**STAFF RECOMMENDATION**  
**407 Greenway Avenue**  
**February 17, 2021**

**Application:** New Construction—Addition  
**District:** Richland-West End Addition Neighborhood Conservation Zoning Overlay  
**Council District:** 24  
**Base Zoning:** R6  
**Map and Parcel Number:** 10405008700  
**Applicant:** Ni Li, Architect  
**Project Lead:** Sean Alexander, sean.alexander@nashville.gov

<p><b>Description of Project:</b> An application to construct a rear dormer and rear addition to an historic house. The rear addition will be stepped in from the right side of the house, and after a span of two feet (2') will step back out six feet (6') wider than the historic house.</p> <p><b>Recommendation Summary:</b> Staff recommends approval of the proposed addition with the following conditions:</p> <ol style="list-style-type: none"><li>1. The foundation material is approved prior to construction; and,</li><li>2. The window and door selections are approved prior to purchase and construction.</li></ol> <p>With these conditions, staff finds that the proposal will meet the design guidelines for new construction in the Richland-West End Addition Neighborhood Conservation Zoning Overlay.</p>	<p>

# A-01

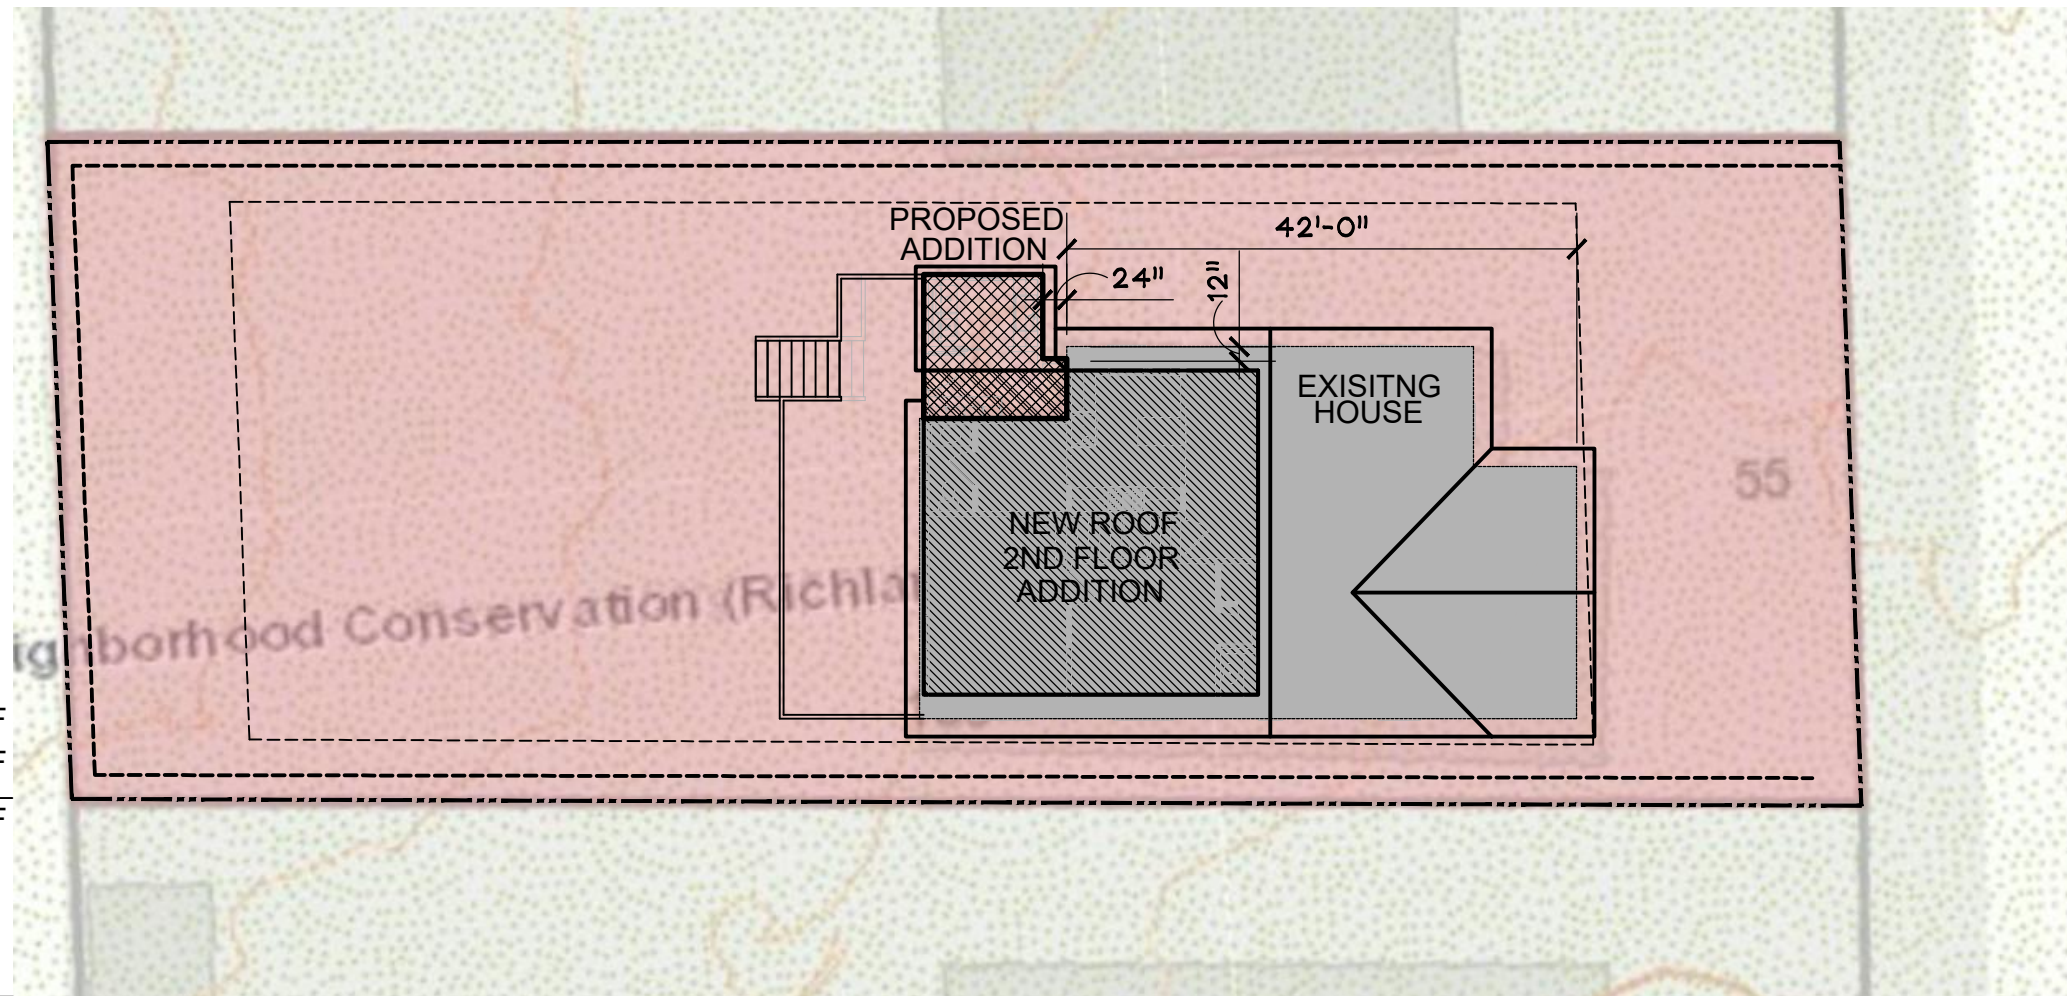
Setback & Rhythm of Spacing: After an inset portion at the rear of the house, the addition will step out six feet (6') wider than the house on the right side. The addition will come no closer than eleven feet (11') from right property line. The addition will not impact the left or rear setbacks.

Staff finds that the setbacks of the proposed addition are appropriate and meet Section II.B.1.c.

**2 BUILDING CROSS SECTION**  
 A-0 SCALE: 1/8"=1'-0"

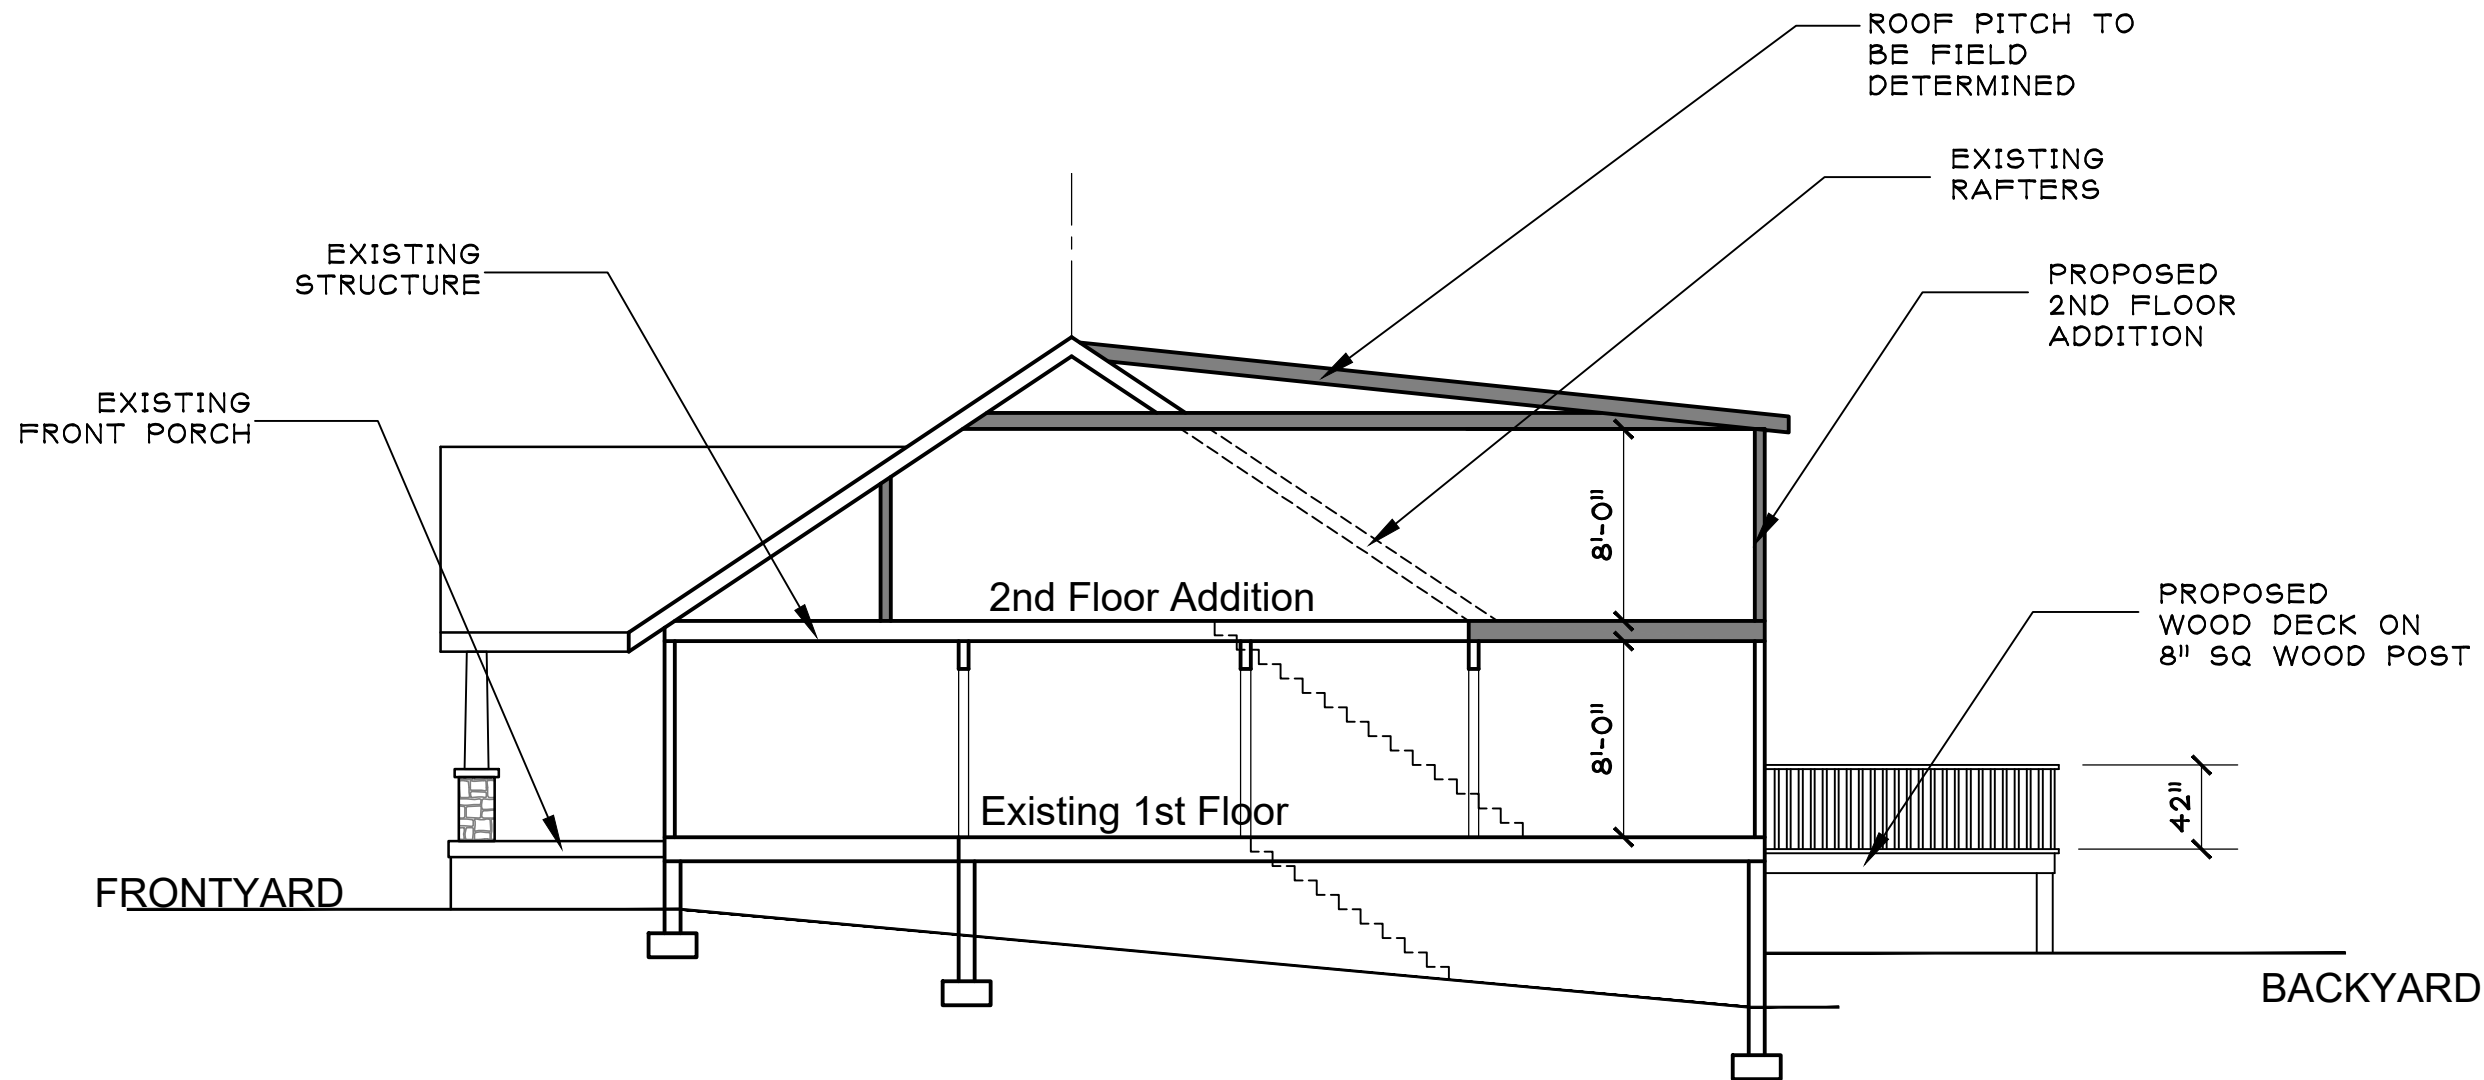
The dormer addition will tie into the rear slope of the existing side-gabled roof just below the ridge and will not go higher.

Roof form: The roof of the dormer addition will be a shed form sloping down toward the rear, with a pitch of approximately 2/12. The first story addition roof will be a shed sloping down to the right, also having a 2/12 pitch.

Staff finds that the roofs of the proposed additions are compatible with the roof of the historic house and meet section II.B.1.e.

**A-03**  
EXTERIOR ELEVATIONS

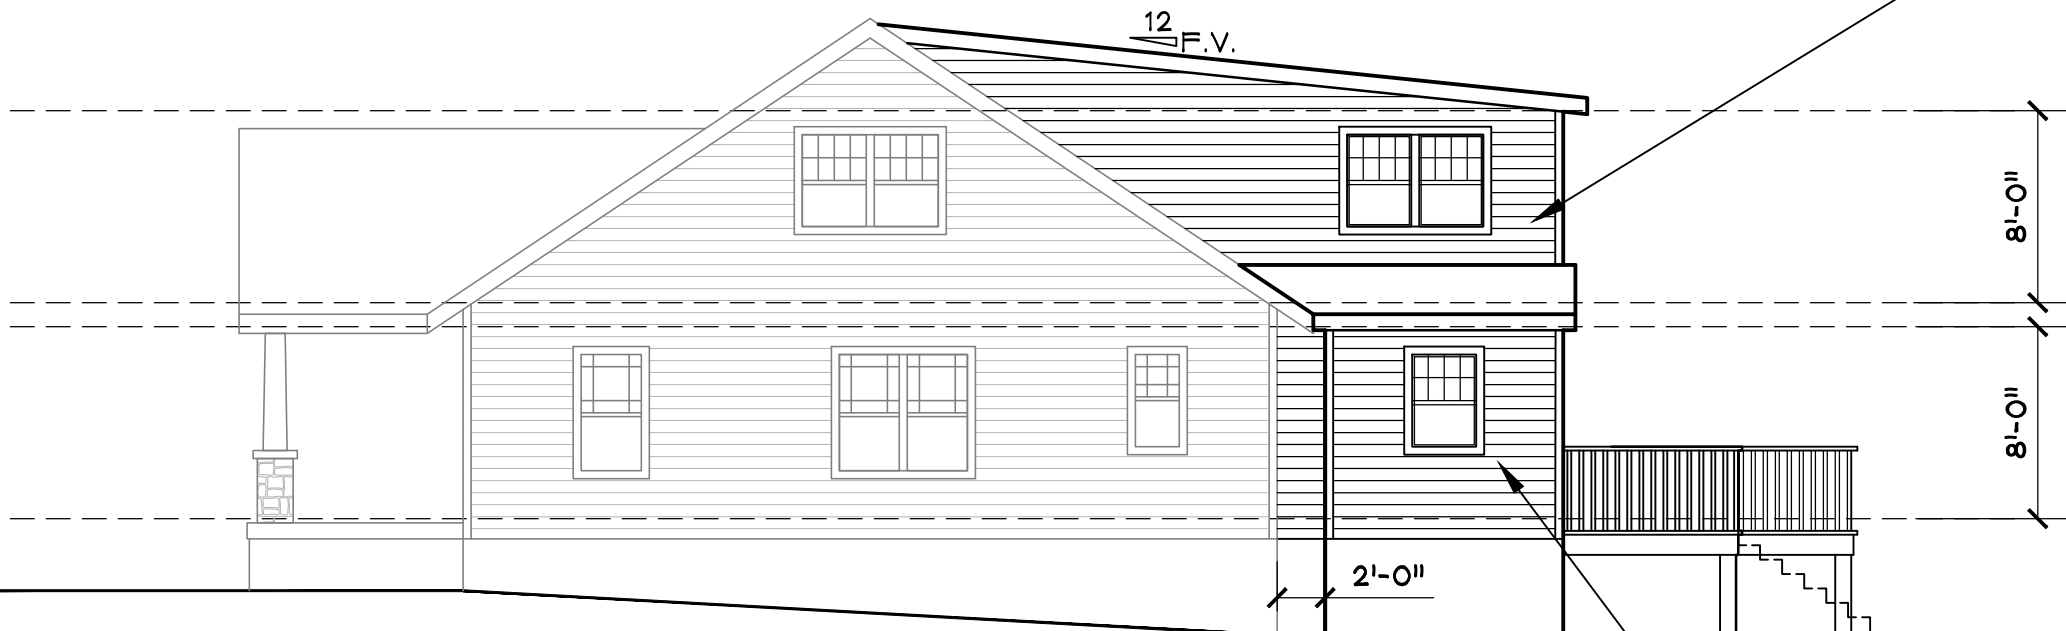
Height & Scale: On the right side, the first story addition will step in one foot (1'), and then after going back two feet, (2') it will step out to the right, going six feet (6') wider than the historic house. The addition will tie into the side of the existing rear addition and will not impact the left side of the building and will not extend the depth of the footprint.

Additions should generally be kept within the silhouette of an historic house, but the design guidelines do allow for additions to go wider when an historic house is shifted to one side of the lot, which is the case for 407 Greenway Avenue. In addition, the wider portion has a low roof, a matching eave height, and extends a minimal amount.

Proportion and Rhythm of Openings: The addition will have windows in the right side on the first story addition and the dormer, matching the type and proportion of windows on the historic house. The left side of the dormer will not have new windows. Dormers historically are found with windows in the sides and without. The front-facing wall of the first story addition will not have a window. Staff finds this to be appropriate because the width of the addition is minimal at only six feet (6').

Staff finds the height and width of the proposed addition to meet Sections II.B.1.a. and b.

Staff finds the project's proportion and rhythm of openings is compatible with the historic house, meeting Section II.B.1.g.
